FREDERICK COUNTY PLANNING COMMISSION

TITLE: **Westwinds, Section VI, Lot 601**

FILE NUMBER: **SP 90-12 (AP# 12117, APFO 12118, FRO 12119)**

REQUEST: **Combined Preliminary/ Final Site Plan**
Requesting re-approval for 73-market rate townhouse on 26.55 acres.

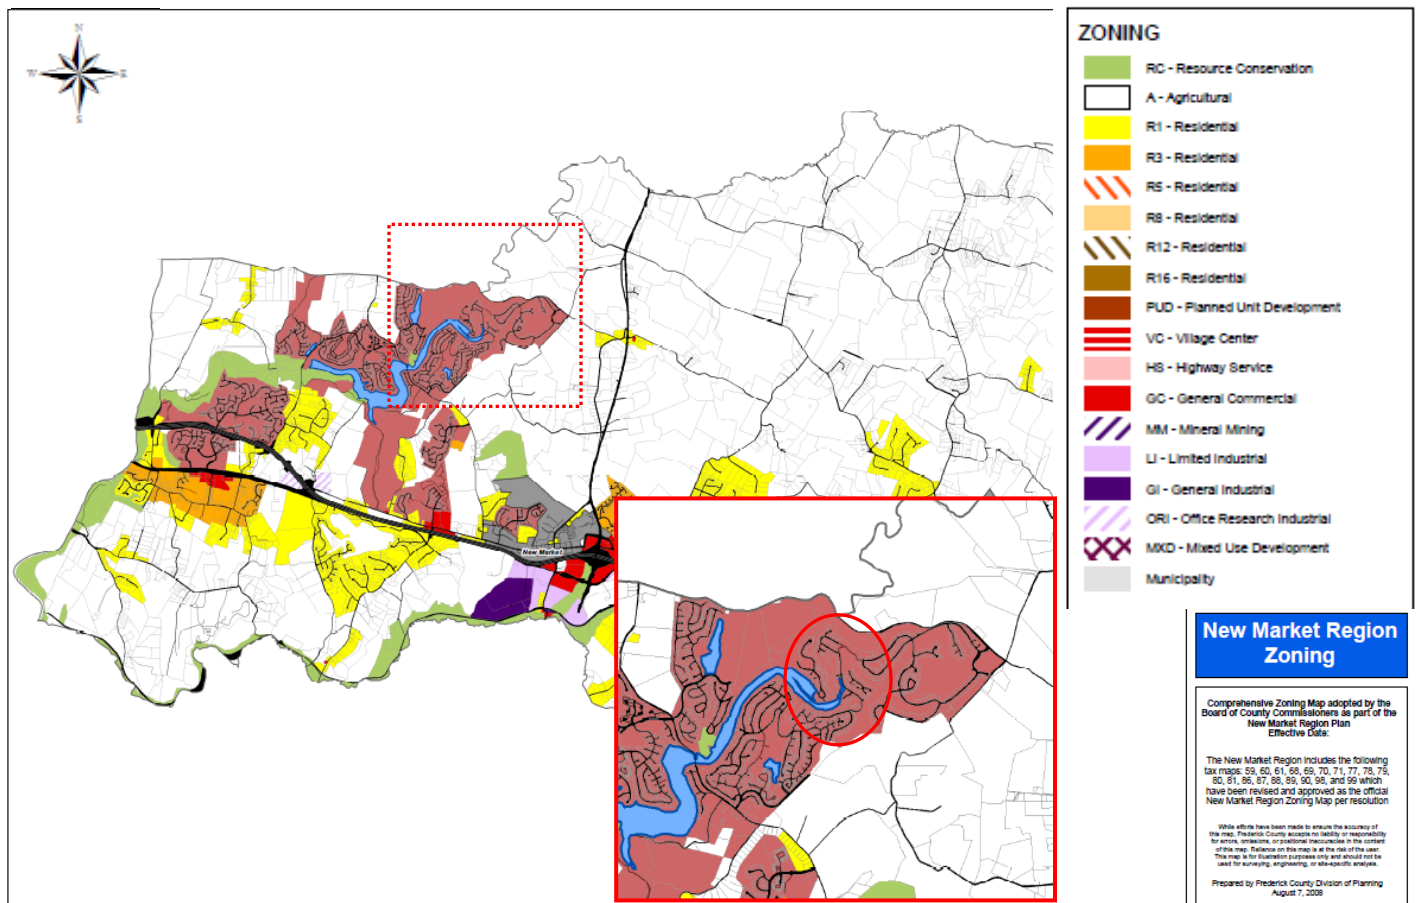
Zoning: The site is located within the Planned Unit Development (PUD) Zoning District, shown in dark red. The adjacent zoning districts are Agricultural (AG), shown in white, and PUD.

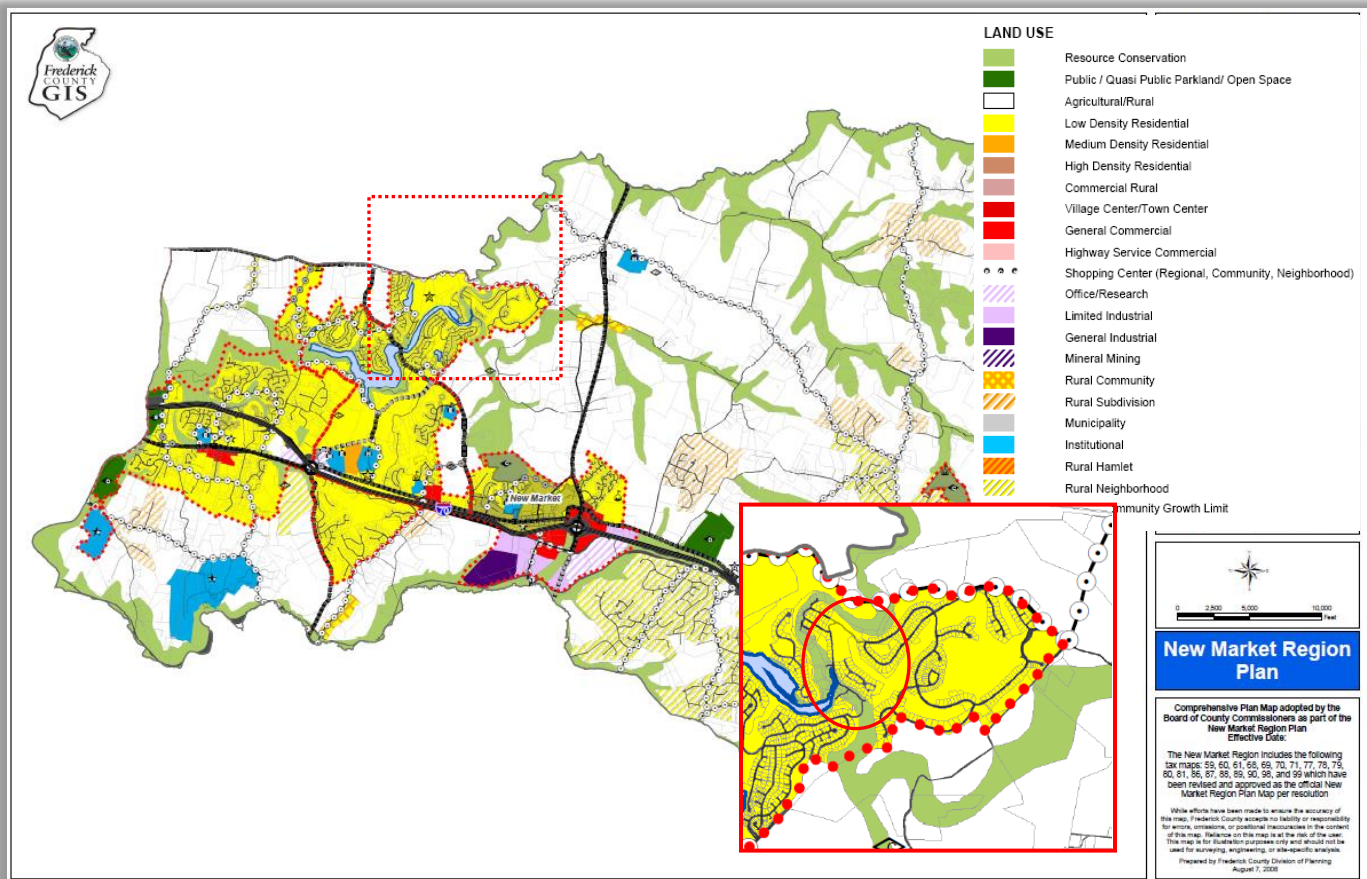
The Applicant is proposing a cathedral roof option with the different unit types being offered. Sheet 6 of the site plan shows the building elevations and height dimensions. The height of the structures (measured from average finished grade to the midpoint of the roof) will vary between 30 feet - 8 1/2 inches to 35 feet - 3 1/4 inches.

In April 2007 the FcPc granted a height modification to allow a height of up to 40 feet. The Applicant is requesting that a height modification be granted up to 46'-4" on this application.

1. Approval of the building height modification request to allow a height of up to 46'-4" feet.
2. Approval of setback modification requests to permit the following:
 - a. 18' front-yard setback
 - b. 0' interior, 6' side-yard setback
 - c. 20' rear-yard
 - d. 23' Garage face to back of sidewalk
3. Site plan approval for a period of no longer than three years from today's date.
4. Parking space modification request 1-19-6.220.A.4
